# **Proposed Marlborough Environment Plan**

**Section 42A Hearings Report for Hearing Commencing  
30 April 2018**

**Report on Submissions and Further Submissions  
Topic: 17 - Subdivision**

**Report prepared by  
Ian Sutherland  
Senior Resource Management Officer**

Figure 1 – Extract from MEP planning map

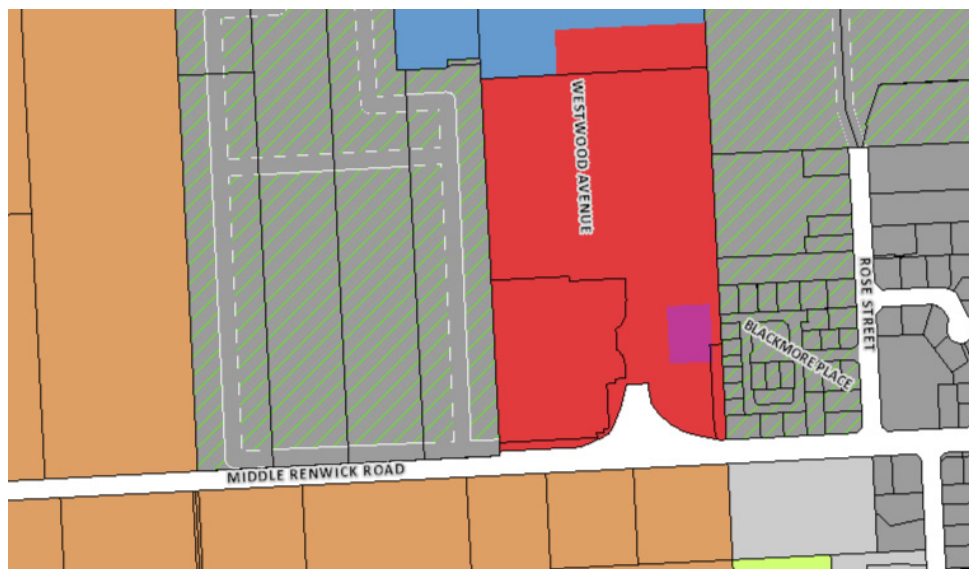
- 301) NZTA (1002.222) support in part Rule 24.4.1.13, but seek to include the need for reverse sensitivity effects against the road network to be considered and mitigated. NZIS (1186) in a further submission have opposed this because the assessment of reverse sensitivity matters associated with subdivisions to include the road network will be costly, difficult to implement, and impractical.
- 302) Standard 24.4.1.13 only applies to the Urban Residential 2 (Greenfield Zone). The only land within that zone fronting a State Highway that has remaining subdivision potential is the 315 metres to the west of Westwood (Pack'n'Sav building), although nearly all of this frontage is identified as being required for an indicative road that will connect back to the round-a-bout – see a copy of planning map 6 in Fig 1 below.

- 303) This should mean that the impacts/costs to new allotments will be very minor as there is likely to be a sufficient buffer with the need to construct this side access road to avoid reverse sensitivity conflicts, however there is the possibility that the location of this side road may move a little and that some residential allotments could be created adjoining the State Highway while obtaining access from a local road. If that occurred, reverse sensitivities could arise from noise and vibration associated with the State Highway, particularly from braking and accelerating if it retains its 100kph speed limit.

Figure 3.8 – Footpath construction – typical sections

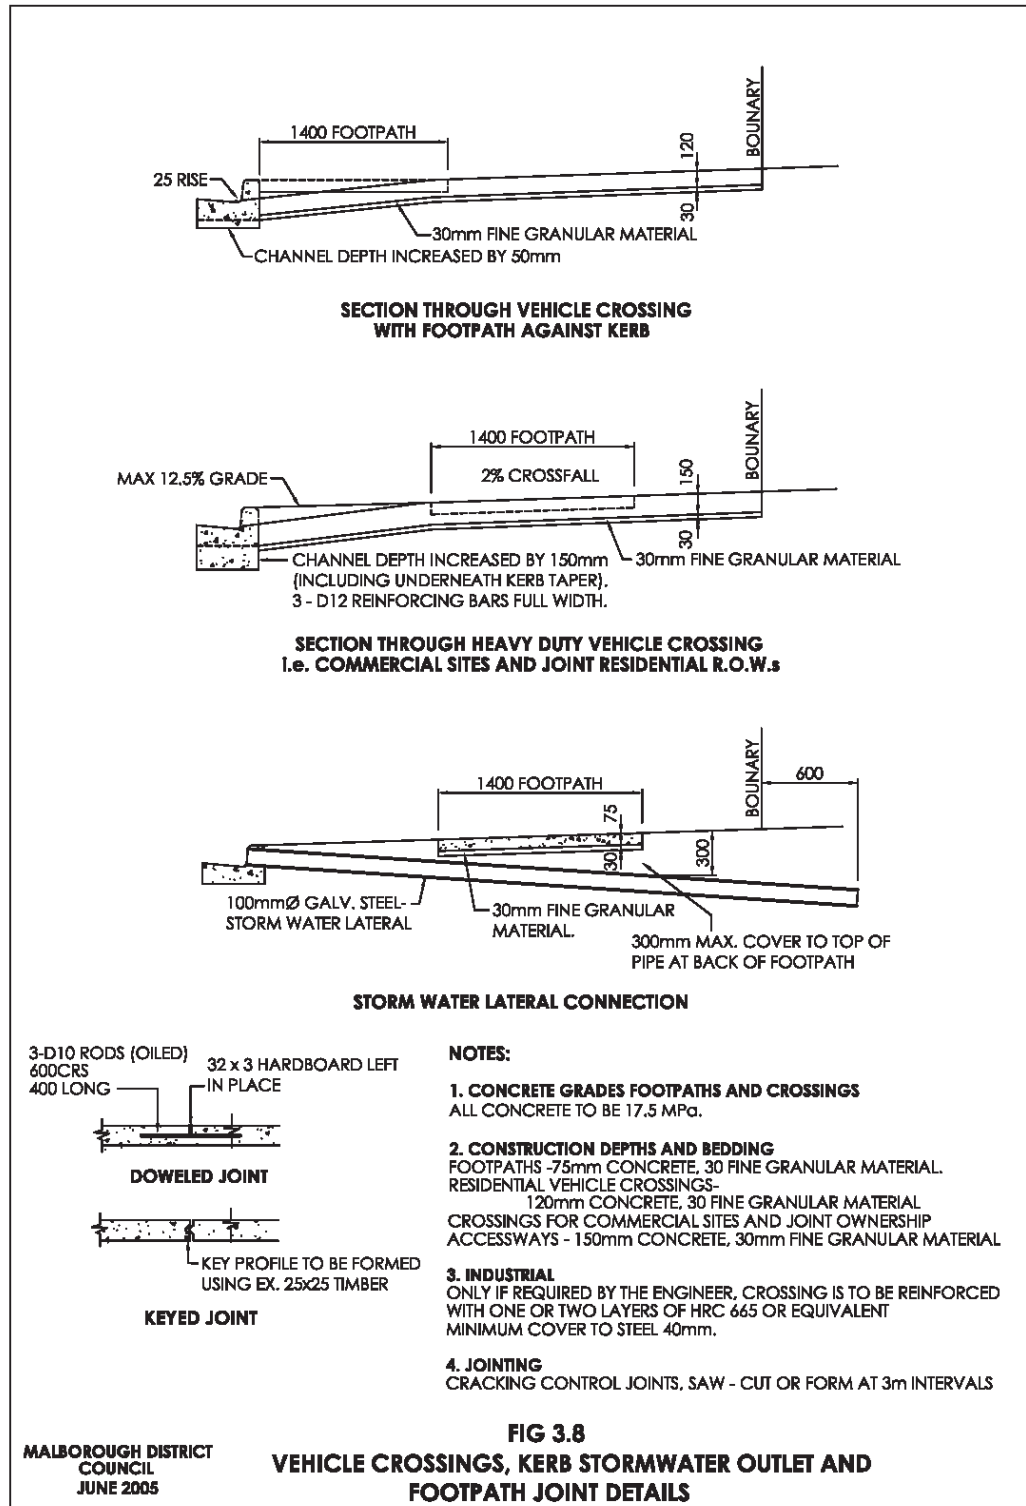
20. Figure 3.8 Footpath construction – typical sections p 65 is replaced with Figure 3.8 Vehicle crossings, kerb stormwater outlet and footpath joint details as follows:

Figure 3.10A Private Access for One Rural User

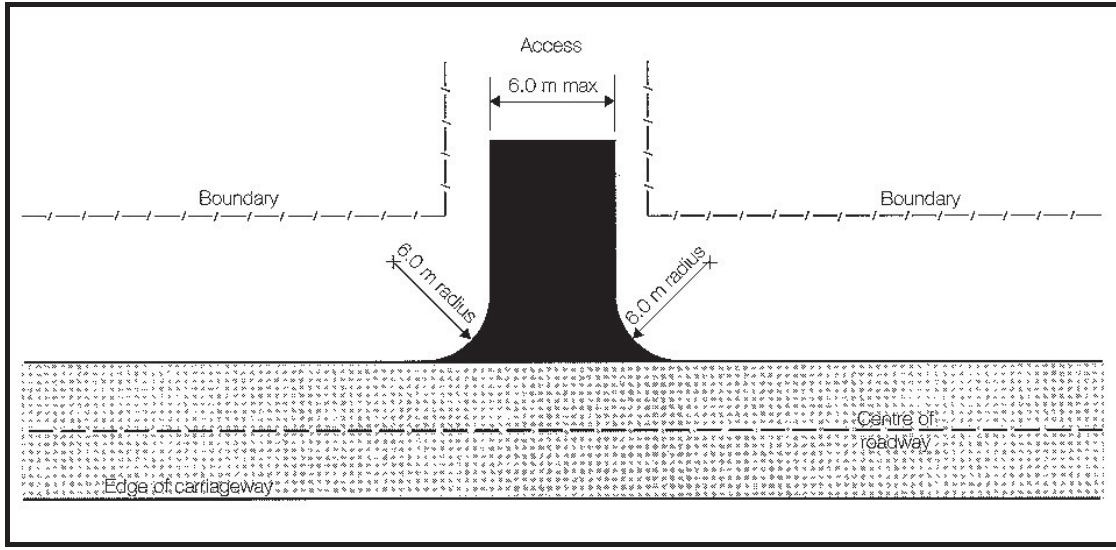
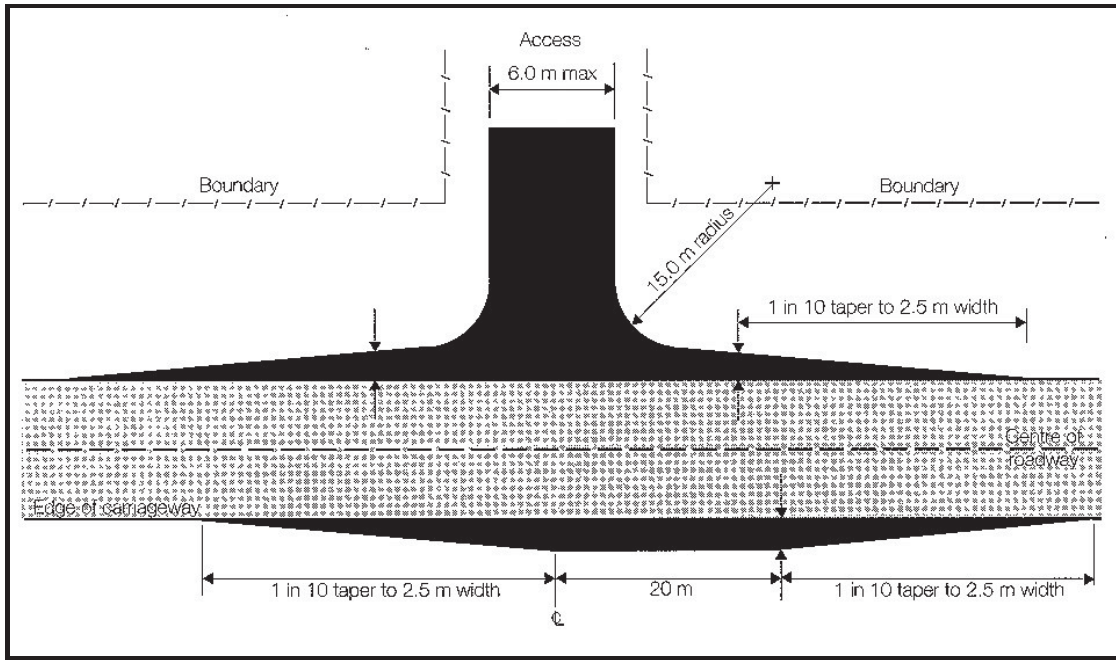
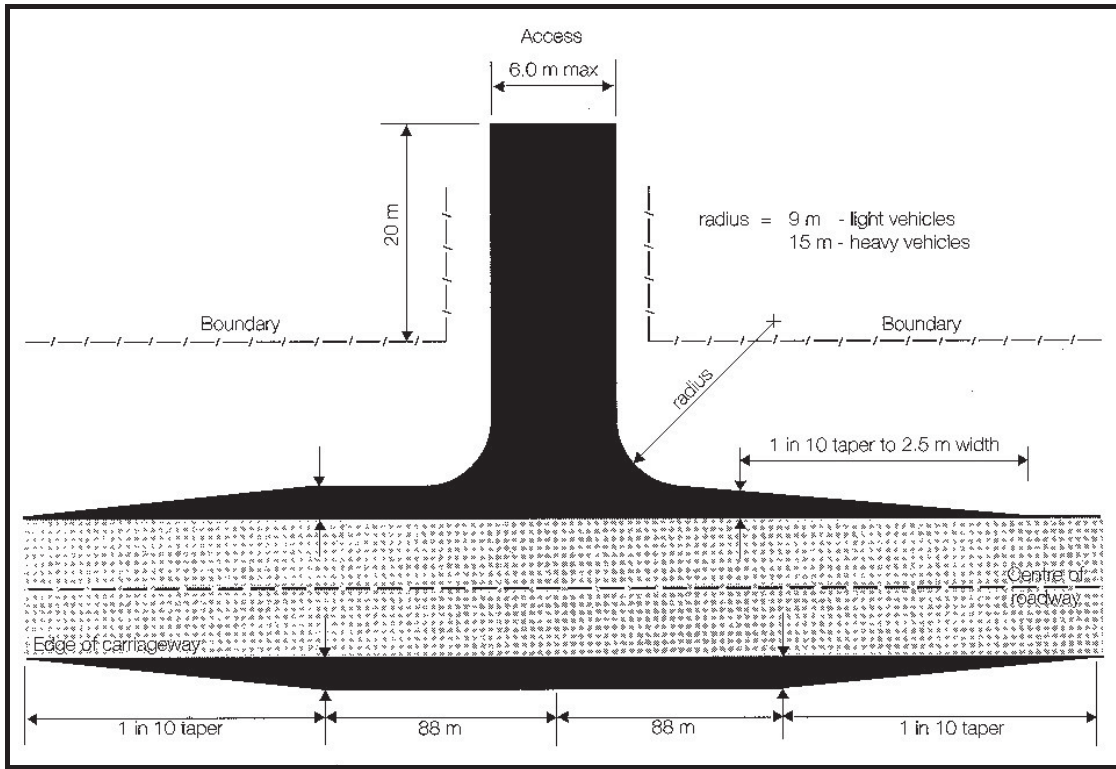
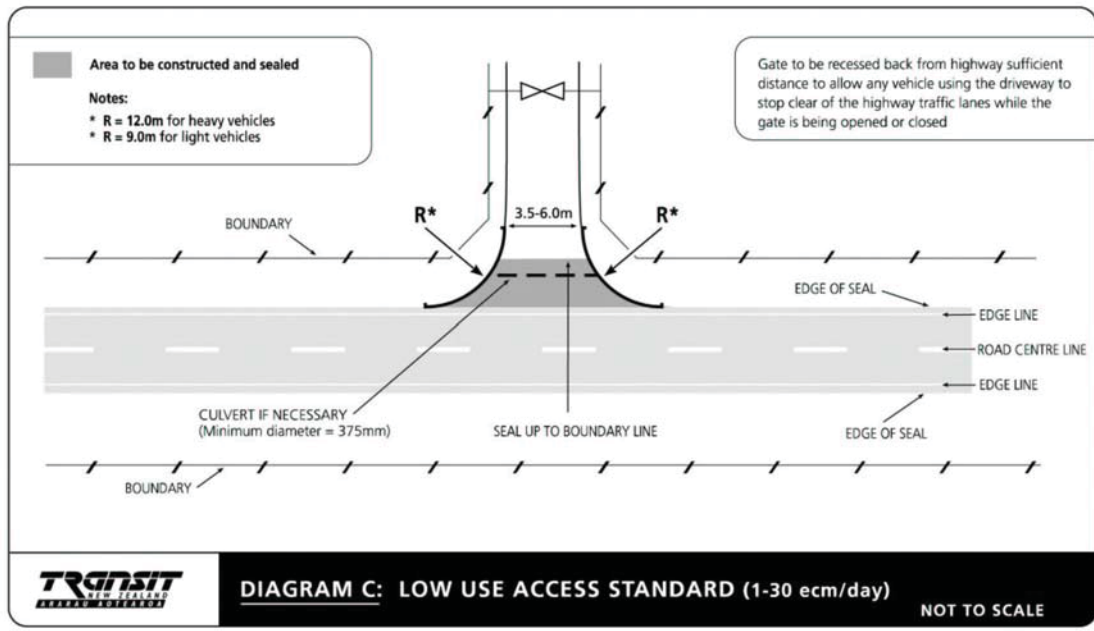
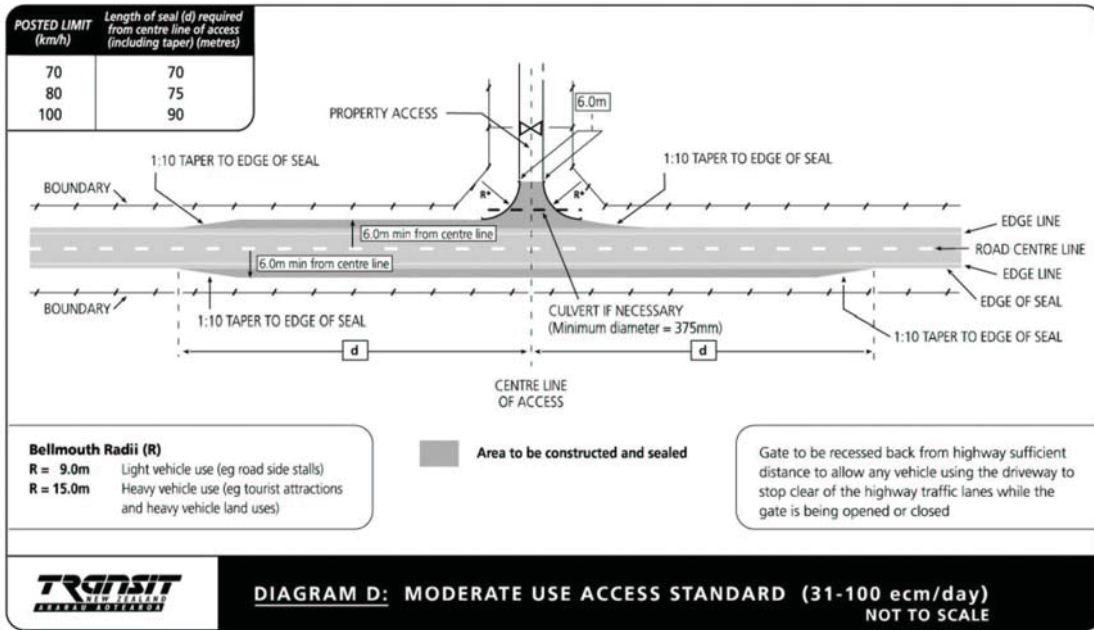
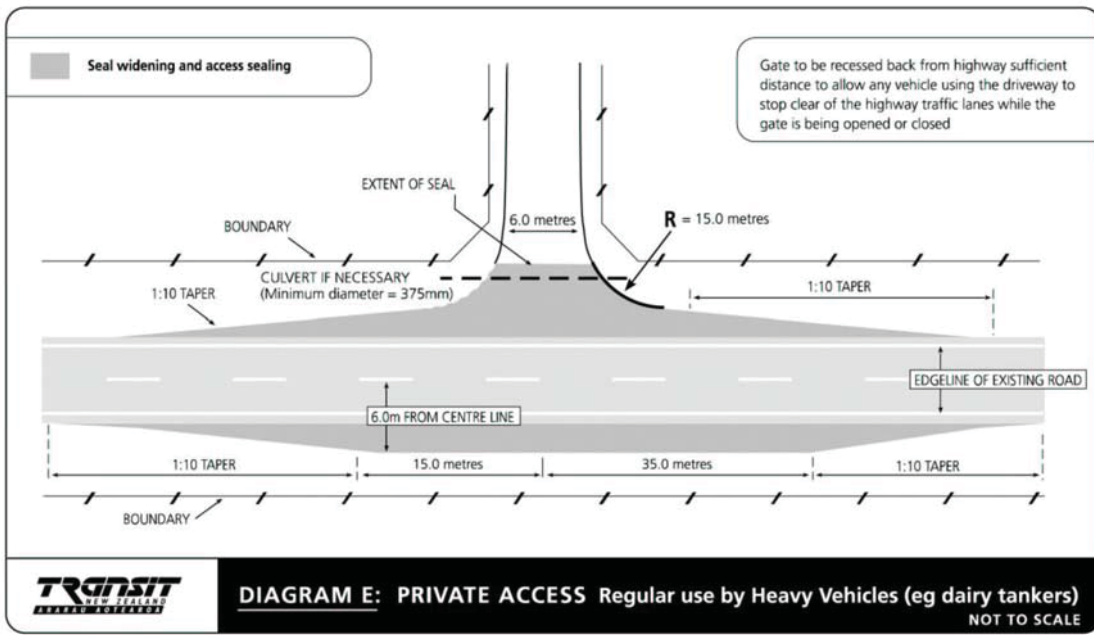
22. Clause 3.3.19 *Rural* p69 is amended by adding the following at the end of the clause and inserting Figures 3.10A to 3.10F after Figure 3.10

Figures 3.10A, 3.10B and 3.10C show an acceptable detail for rural accesses on roads other than state highways, based on the number and type of users of the road. (Note: these figures are Figures 11, 12 and 13 in the Proposed

Figures 3.10D, 3.10E and 3.10F show acceptable detail for rural accesses onto state highways based on the level of use. (Note: these figures are Diagrams C, D and E from Transit New Zealand's Planning Policy Manual. Figures 26.9, 26.10 and 26.11 in the Marlborough Sounds Resource Management Plan specify the permitted activity standards for accesses onto State Highways within the Marlborough Sounds).

Figure 3.10 – Standard light duty vehicle crossing detail

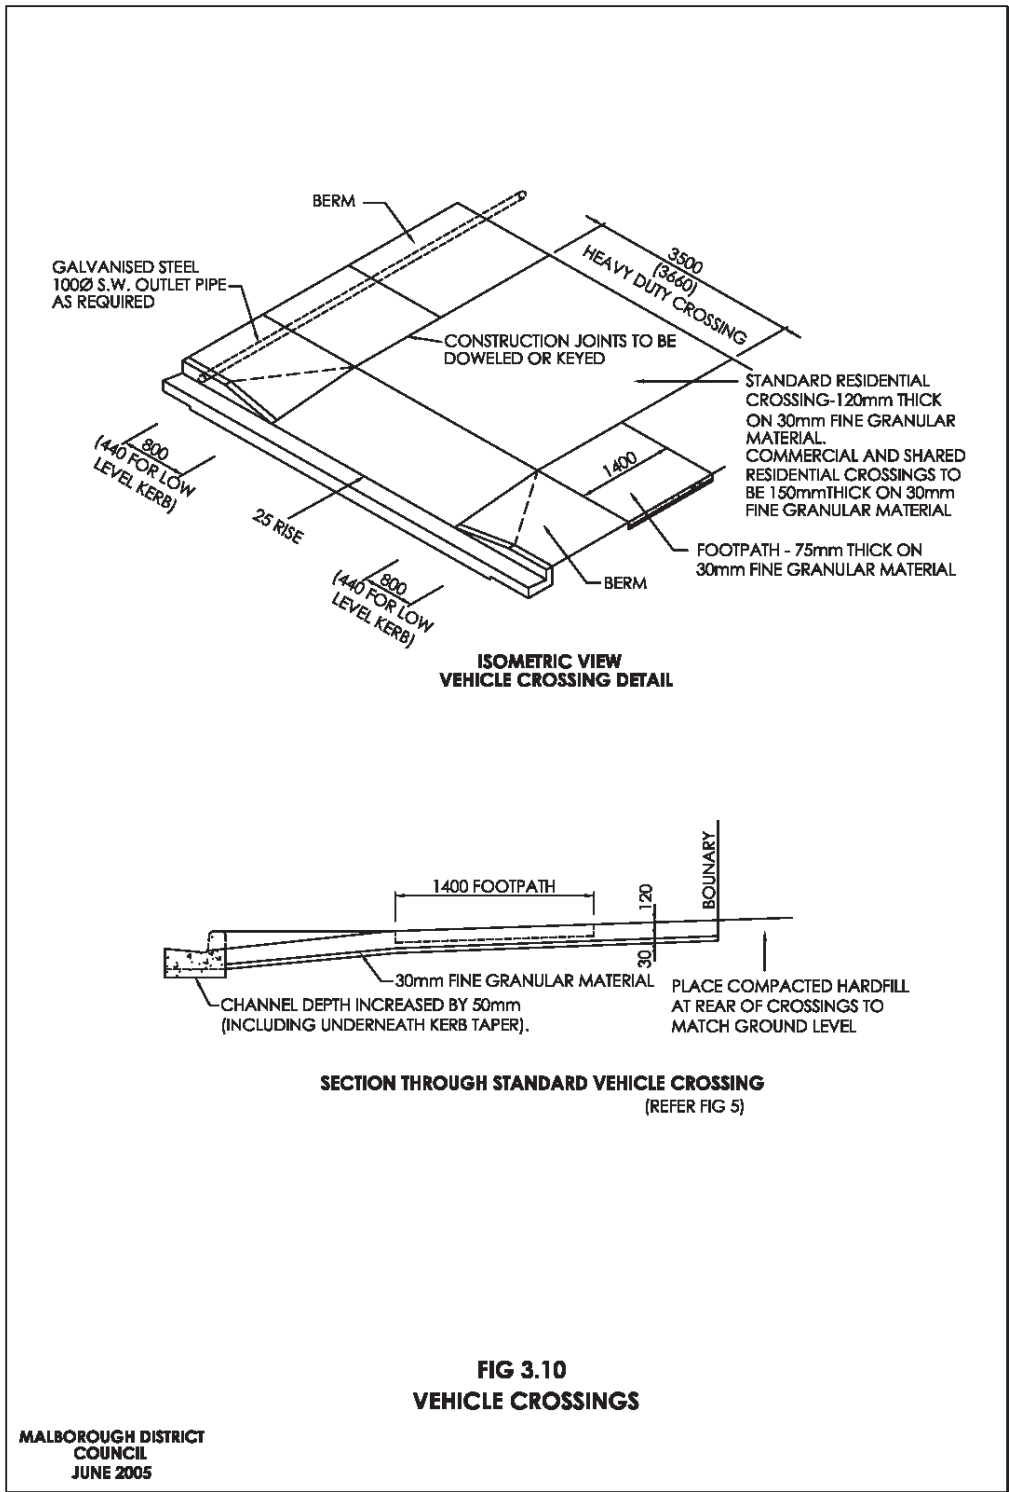
23. Replace Figure 3.10 - Standard light duty vehicle crossing detail p71 with Figure 3.10 – Vehicle Crossings as follows:

Figure 3.12— Kerbs and dished channels

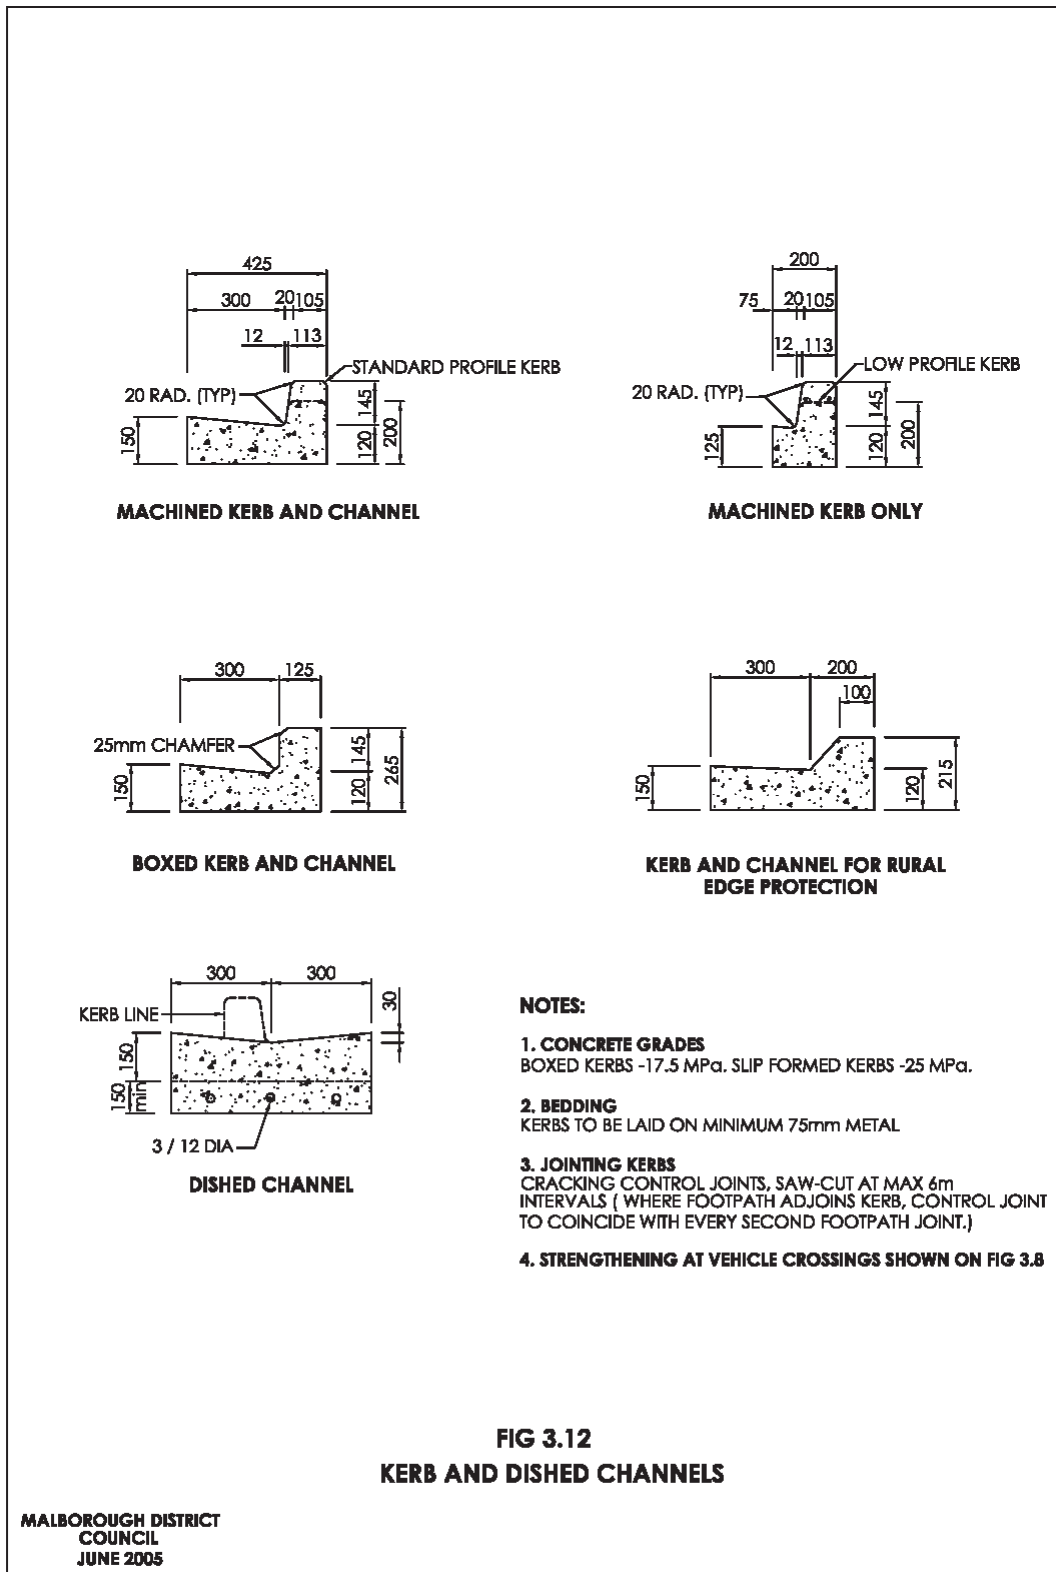
25. Replace Figure 3.12 – Kerb and dished channels p 75 as follows:
